**Re: Waste Licence Application W0231-01**

**Fingal Landfill**

**Submission to the Re-Opened EPA Oral Hearing**

**27<sup>th</sup> April, 2009**

**Figure 2 - 20,000 Years into the Past**

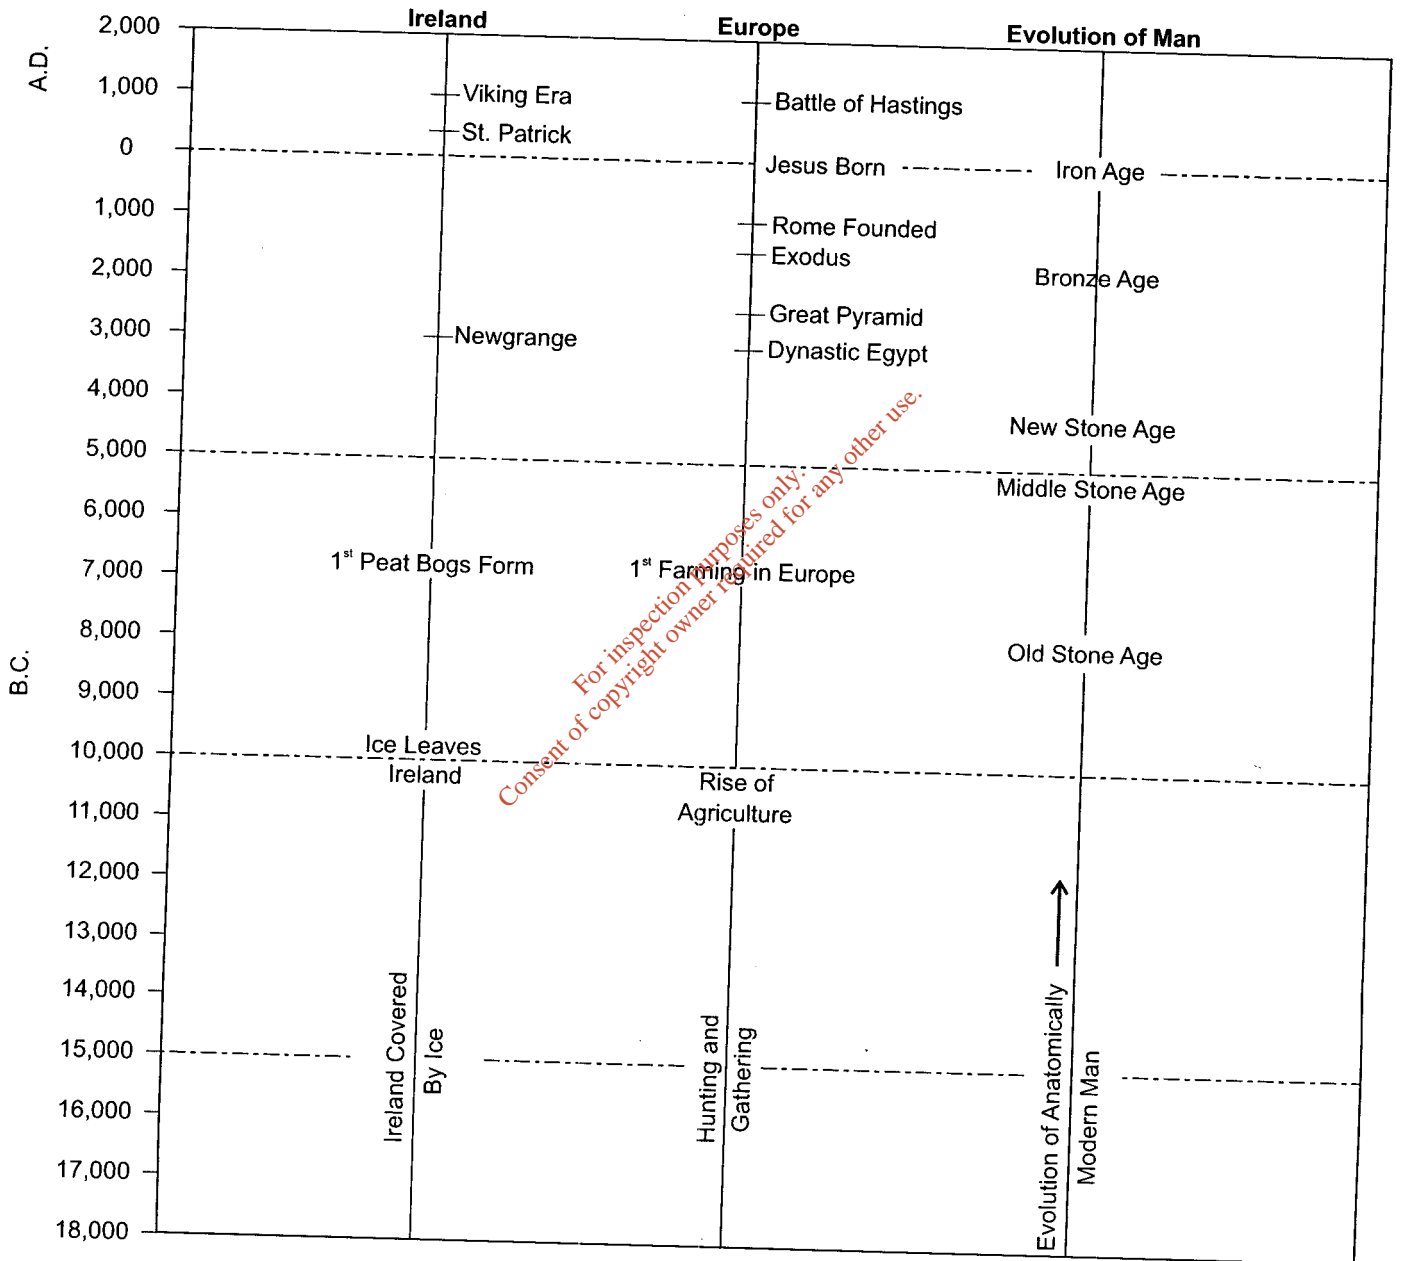
Having failed to get any guidance on how long 20,000 years might be in the future I decided to look backwards into historical time to see if that would help me. Figure 2 illustrates my findings.

In the Irish context, a 1,000 years ago brings us to the Vikings, then to St. Patrick about 1,550 years ago and further back we have Newgrange at 5,000 years old. I would of course defer to Mr. Boyle's archaeological knowledge for the dating of developments that took place between the building of Newgrange and the arrival of Christianity into Ireland.

The bogs formed some 7,000 years ago, i.e. some 3,000 years after the ice caps left the island. Unfortunately it is not possible to go back as far as the Applicant's 20,000 years in Ireland as the island was covered by ice for the last 8,000 to 10,000 years of the 20,000 year span.

Turning to Europe we see that the Egyptian Dynasty roughly equates to Newgrange in Ireland with Newgrange being about 500 years older. Further back on the European mainland, which was not glaciated in the Pleistocene Period, we then pass through the 1<sup>st</sup> development of agriculture in Europe and further back to when humans were just hunter gatherers.

Putting the Applicants 20,000 years into human development terms we can see that this length of time lies beyond the stone age and equates to when it is generally believed that our ancestors evolved anatomically into modern man!

Figure 3

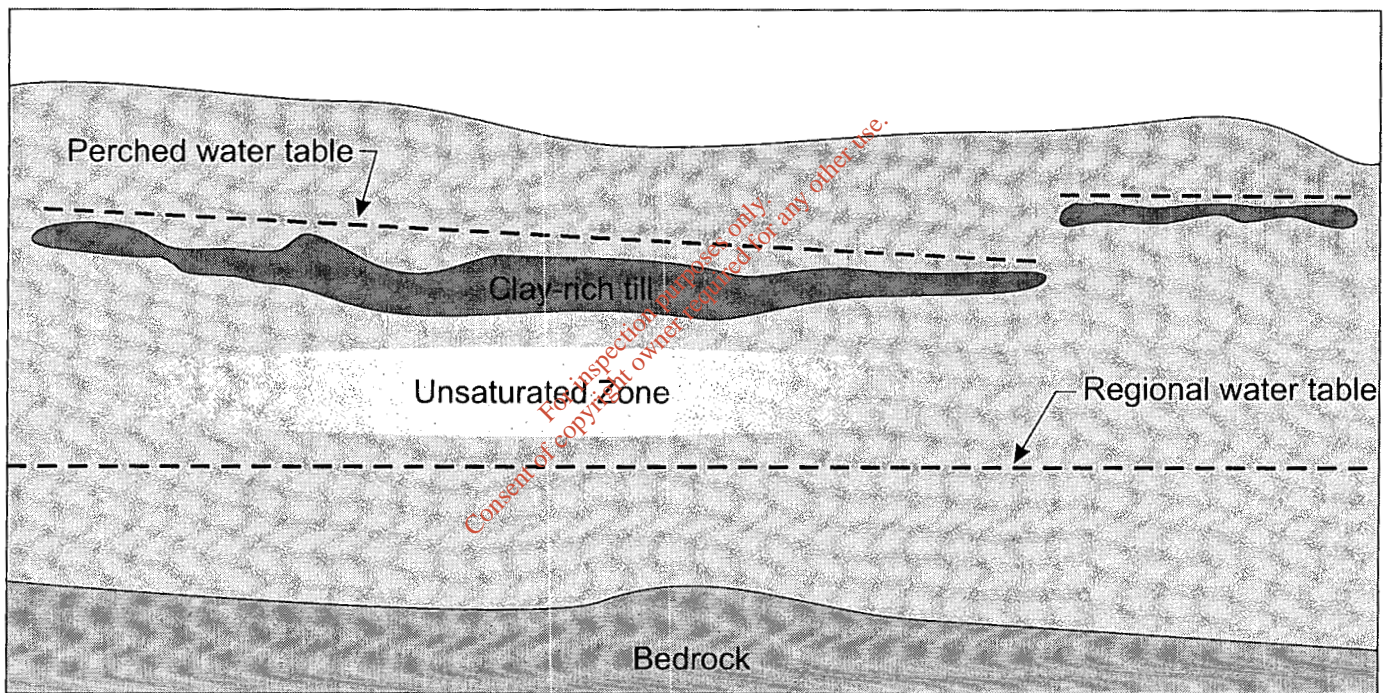
You will appreciate Mr. Inspector that the previous 20,000 years included such seismic global climatic changes as the melting of a continental ice cap about 10,000 years ago (Figure 3); not an insignificant or every day event you will accept I am sure.

**Figure 5 - Groundwater Levels at Nevitt**

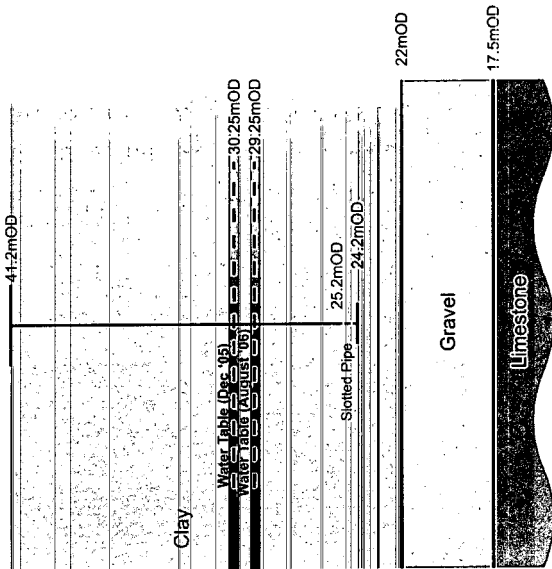
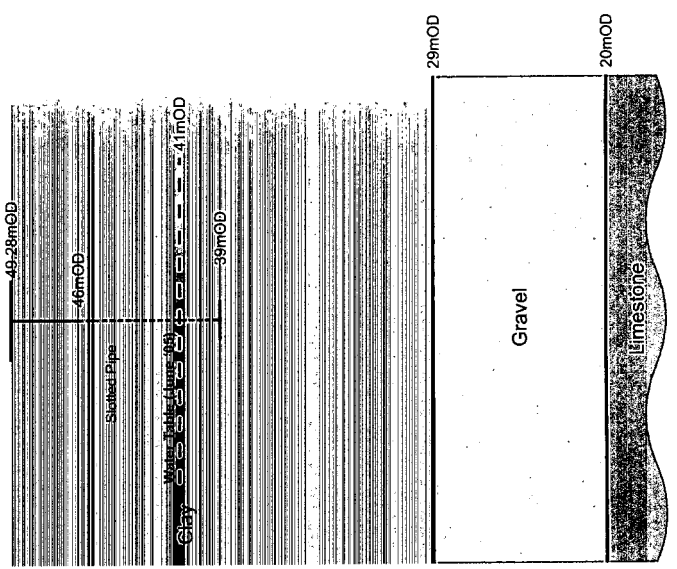
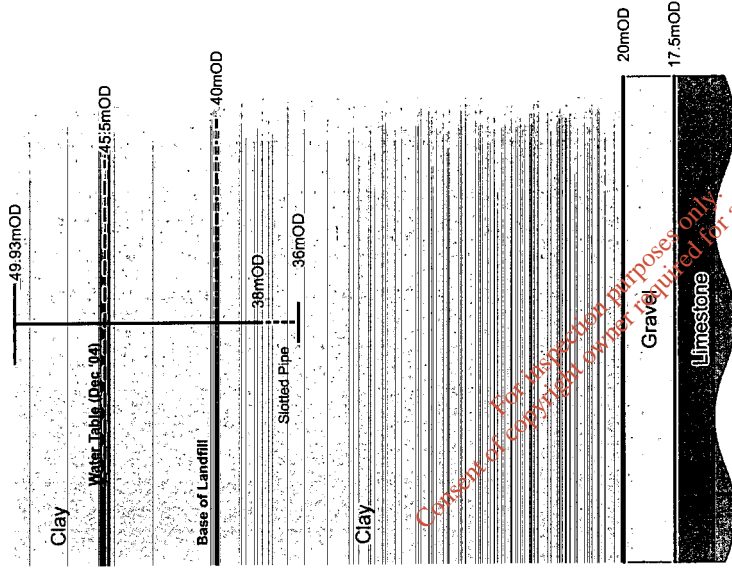
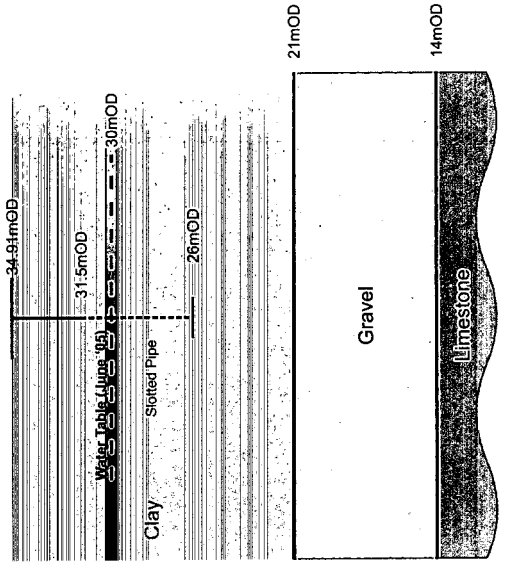
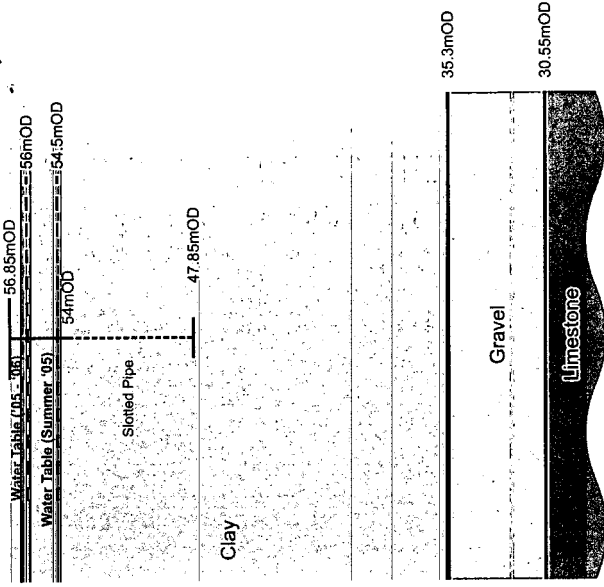
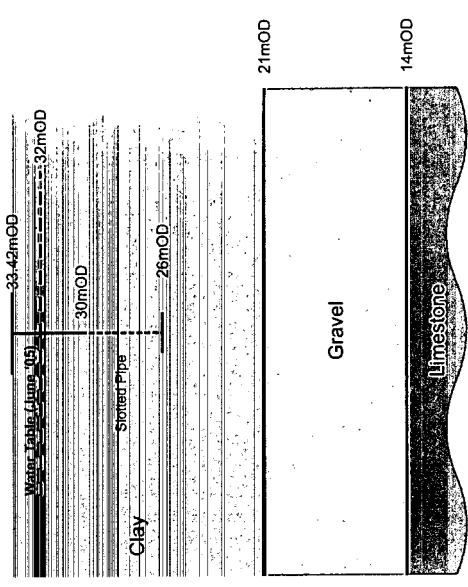
As indicated on the attached Figure 5 the numerous standpipes located in the clay overburden by the Applicant indicate the presence of a single regional water table at the Nevitt site and surrounding lands.

None of the shallow groundwater monitoring boreholes completed by the Applicant indicate or even suggest the presence of a perched water table either within or outside the landfill footprint.

As indicated on Figure 5 the wide range of depths at which the standpipes are located discounts the possible presence of a dry or unsaturated zone between the supposed perched water table and a lower regional water table.

**Figure 6 Groundwater Levels at BSA4 (CLAY)**

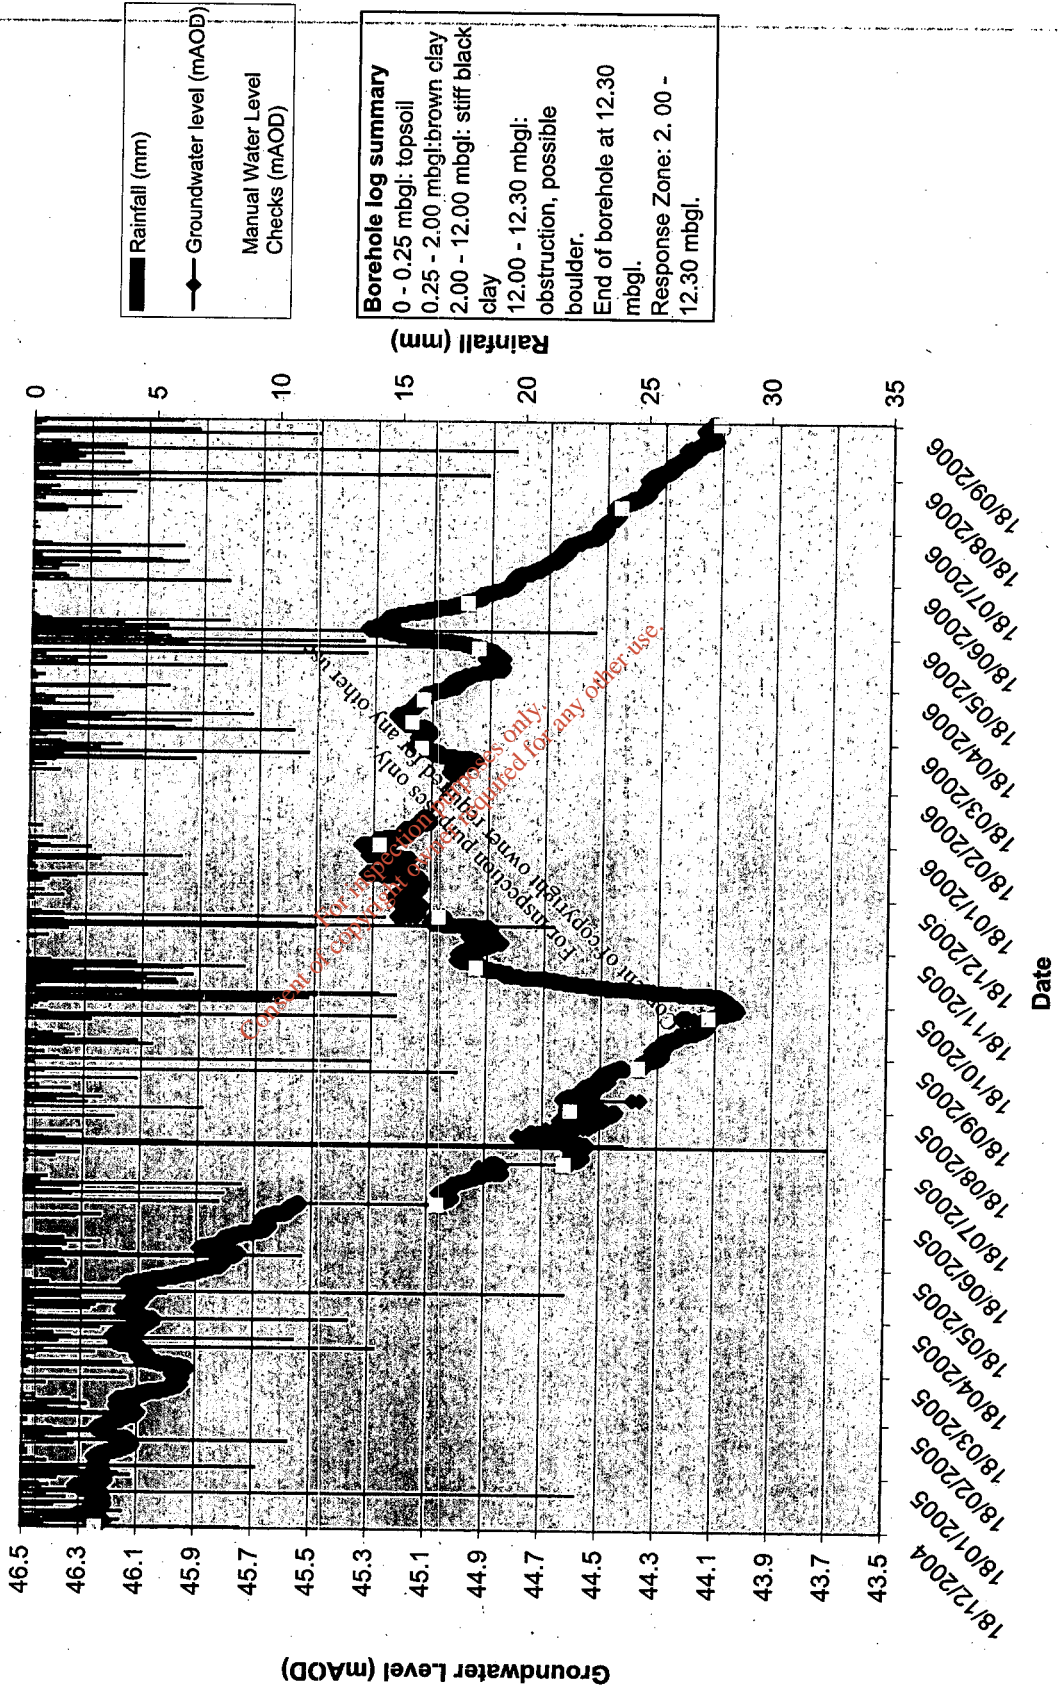
The storing and movement of groundwater in the overburden deposits below the footprint is clearly shown by the Applicant's seasonal hydrograph (Figure 6) for the monitoring well BSA4 located in the southern part of the footprint. In this hydrograph the overburden aquifer is seen rapidly recharging with winter rainfall and then gradually discharging to the local drainage network during the summer and autumn periods. A similar picture occurs at BSA6 beneath the northern part of the footprint.

The BSA 4 hydrograph is a typical hydrograph from a water table aquifer. Therefore, even taking the Applicant's interpretation of the Agency's request as a reasonable proposition it is clear that the first aquifer beneath the site is in fact the clay overburden water table aquifer. The Applicant should therefore have addressed the potential impact of a leachate escape on the groundwater in this water table aquifer rather than focusing exclusively on the much deeper confined gravel/bedrock aquifer unit.

It is plainly obvious that in the event of a leachate escape in the vicinity of BSA4 there will an immediate contamination of the groundwater by List 1 substances without the protection of an intervening unsaturated subsoil. A direct discharge of List I substances to groundwater perhaps ?

As seen from the Applicant's BSA4 hydrograph (which is located in the lowest part of the footprint and therefore in the area of greatest vulnerability to leachate escape, ref. Applicant's Figure 6) any leachate discharge in the vicinity of BSA4 will firstly pollute the groundwater here and then move with the shallow groundwater with the potential to enter the local drainage network to the east and south of the footprint.

- i) correct the conceptual model regarding the perched water table in the overburden
- ii) relocate the 1st Compliance Point to the position of the regional water table at BSA4
- iii) relocate the 2<sup>nd</sup> groundwater Compliance point some distance downgradient of BSA4
- iv) consider potential impacts of leachate migration on the drainage network downgradient of BSA4
- v) furnish the numerical model and the revised geological map which were also sought by the Agency as far back as late 2006 but which were never delivered by the Applicant.
- vi) Present a water table map with summer and winter levels using the 25 monitoring wells located in the clay overburden.
- vii) Present a water table and piezometric maps indicating the impact of the drainage layer on the summer water table levels away from the footprint and in both the overburden and the underlying gravel bedrock aquifers.

**Figure 7** Groundwater Levels at BSA3a (Clay)

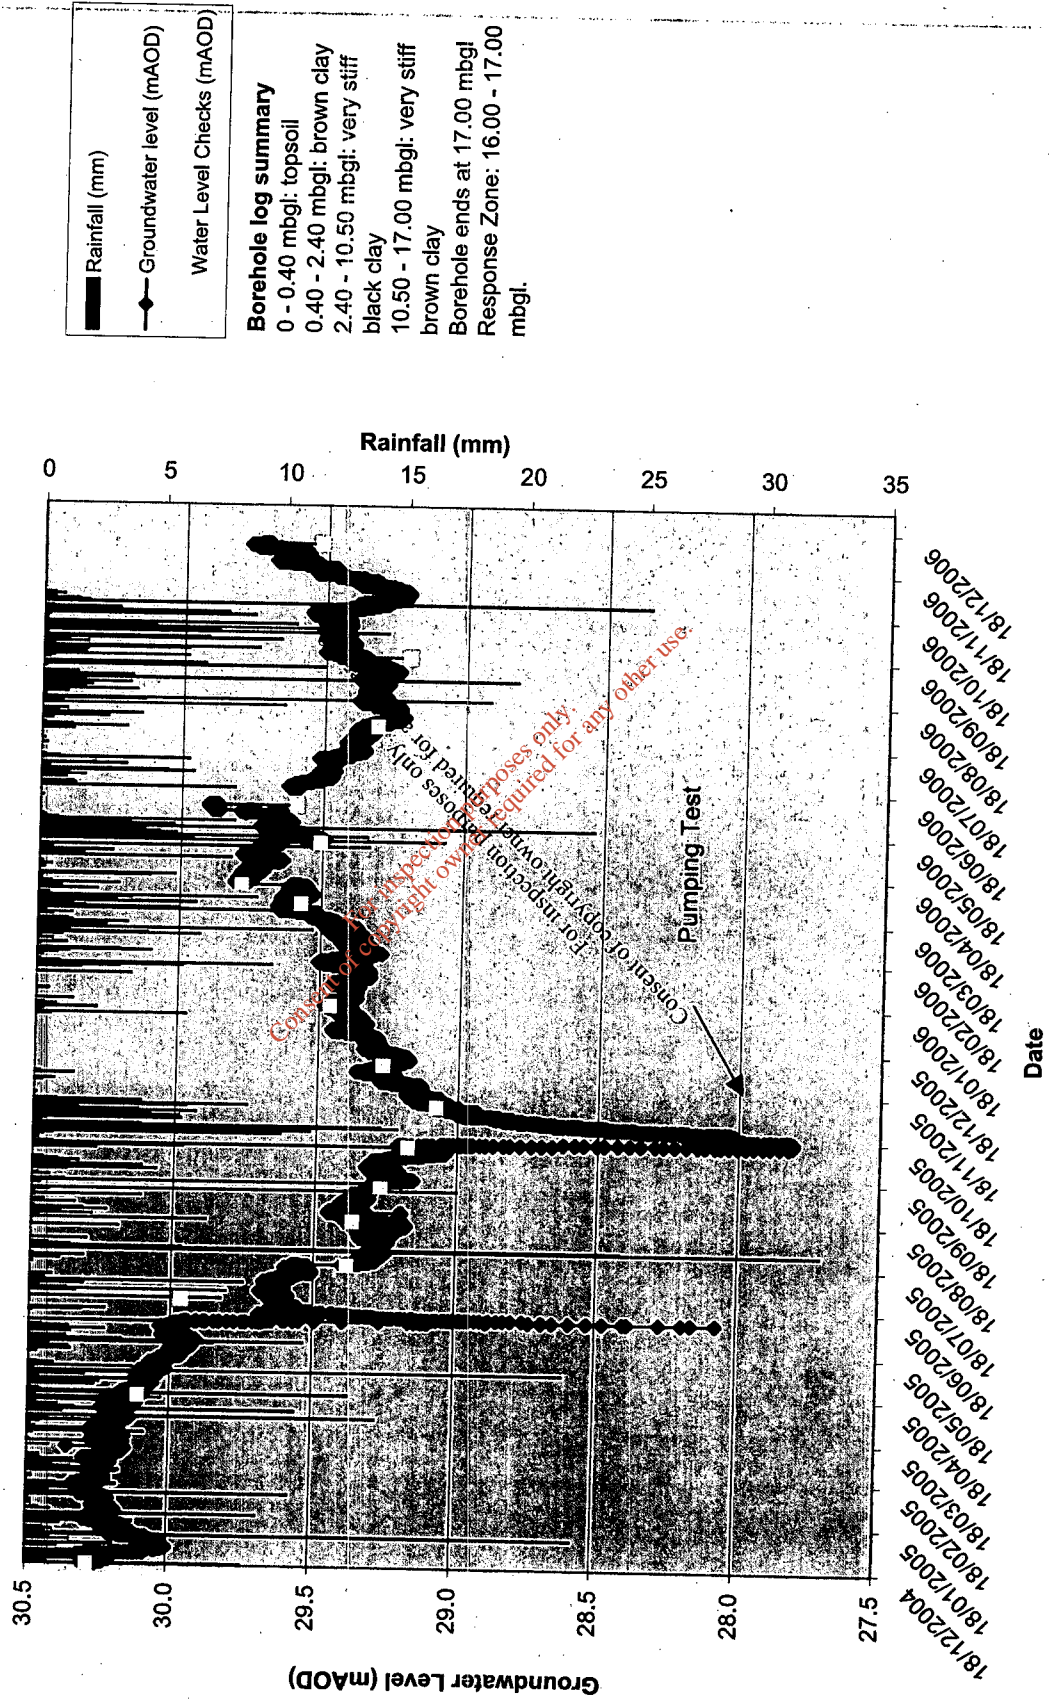
The reported responses of groundwater levels within the clay overburden to pumping tests, as outlined on page 35 of Volume 5 of the EIS, confirm that all the formations below the regional water table are hydraulically connected. The hydrograph from BSA3a (Figure 7) shows a direct connection with the pumping test carried out in the underlying gravel / bedrock unit and the water table in the clay overburden. BSA3a is over 500m away from the pumped wells. Is anyone suggesting that the water table in BSA3a is not the regional water table? Is the Applicant suggesting that the water table shown in BSA4 (Figure 6) located within the landfill footprint is not the regional water table?
